SUBJECT: Transmittal of Westinghouse Responses to US NRC Requests for Additional Information on the AP1000 Application for Design Certification

AP1000 DESIGN CERTIFICATION REVIEW

Response to Request For Additional Information

Figure 650.006-1 AP1000 Coating Debris Settling (Front)

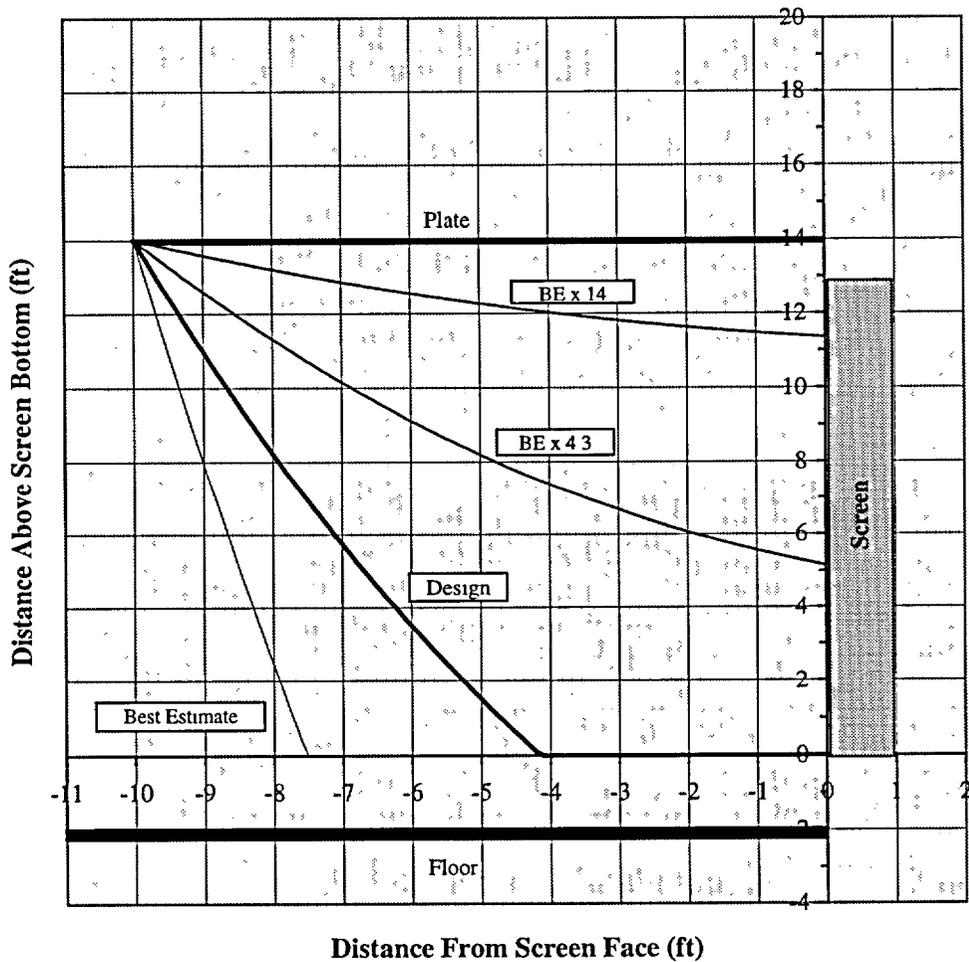
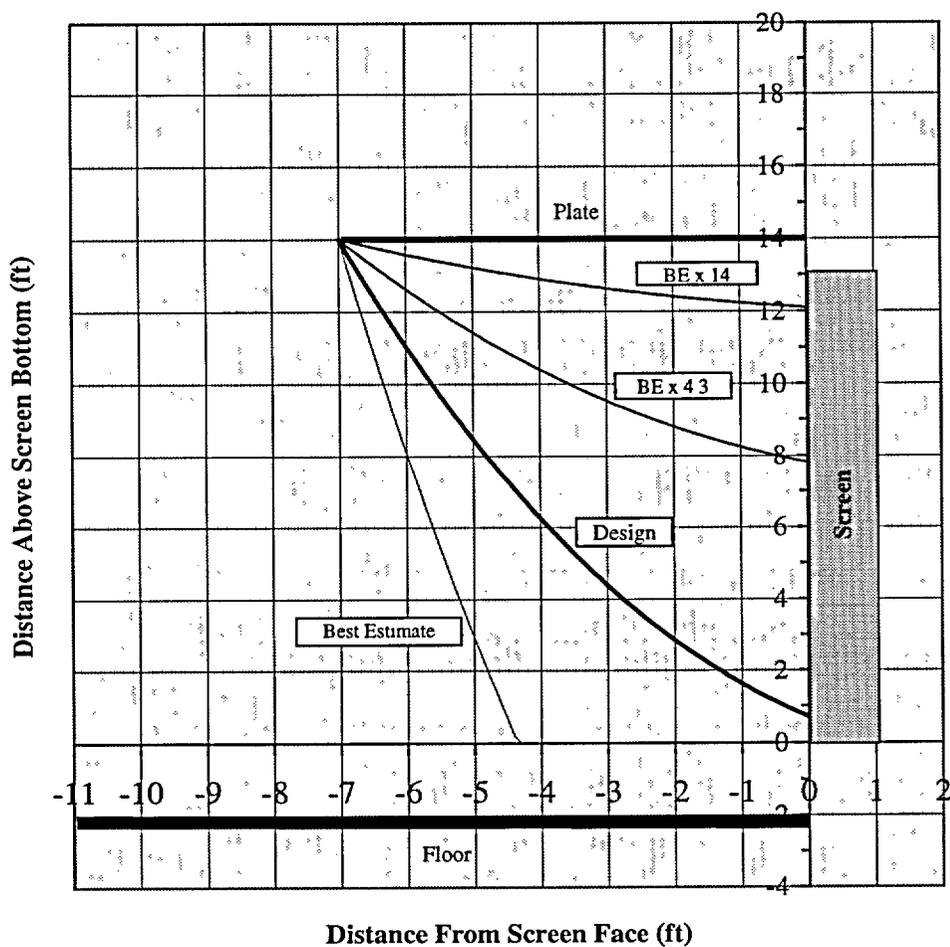
On the basis of research and analysis undertaken to support the NRC staff's efforts in resolving Generic Safety Issue 191 (GSI-191), Assessment of Debris Accumulation on PWR Sump Performance, the staff questions the validity of the conclusion that fibrous debris will not be generated by a LOCA at an AP1000 reactor. Specifically, the NRC staff and licensees of currently operating plants have identified that the loose dispersion of dust and dirt that resides on the surfaces of the components and structures within the containment can consist of significant amounts of fibrous material, even at plants that do not deploy fibrous insulation in the zones of insulation destruction for postulated pipe ruptures. It is thought that the constituents of this resident fibrous material originate from such items as cloth protective clothing and equipment covers, human hair, fines from fibrous material (e.g., thermal insulation and fire barriers) outside of destruction zones, and sources external to the containment (when the equipment hatch or other containment apertures are open). This fine, dispersed resident fibrous material may be washed down toward the IRWST or containment recirculation screens by break flows, condensate droplets, or other containment drainage flows, and its fineness allows it to remain in suspension for extended periods in a pool of water, even at low turbulence conditions.

Figures 650.006-1 and -2 show the settling trajectories of coating debris starting at the edge of the protective plate. Figure 650.006-1 shows the approach from the front of the screen and figure 650.006-2 shows the approach from the side. Such debris can not enter the water any closer to the screens because no coatings are permitted any closer to the screens. The figure shows that with design settling rates the debris will settle to the elevation of the bottom of the screen after drifting about 6 feet, which is at about 4 feet away from the screen. Significant conservatism was included in this evaluation, including assuming the lightest/smallest coating debris. It also assumes the maximum recirculation flow of 1600 gpm, consistent with the maximum flow from two RNS pump operating unthrottled with suction taken from two screens. Another area where significant margin has been applied is in the debris settling rates. AP1000 uses debris settling rates that contain a factor of two margin compared to the reference settling data (Reference 1) which is sufficient to account for uncertainties. Without this added margin, the coating debris settles out very quickly in less than 3 feet, as shown in Figure 650.006-1 and -2.

The debris settling shown in figures 650.006-1 and -2 provide confidence that the plant can sustain complete failure of the nonsafety-related coatings located inside containment without excessive blockage of the recirculation screens.
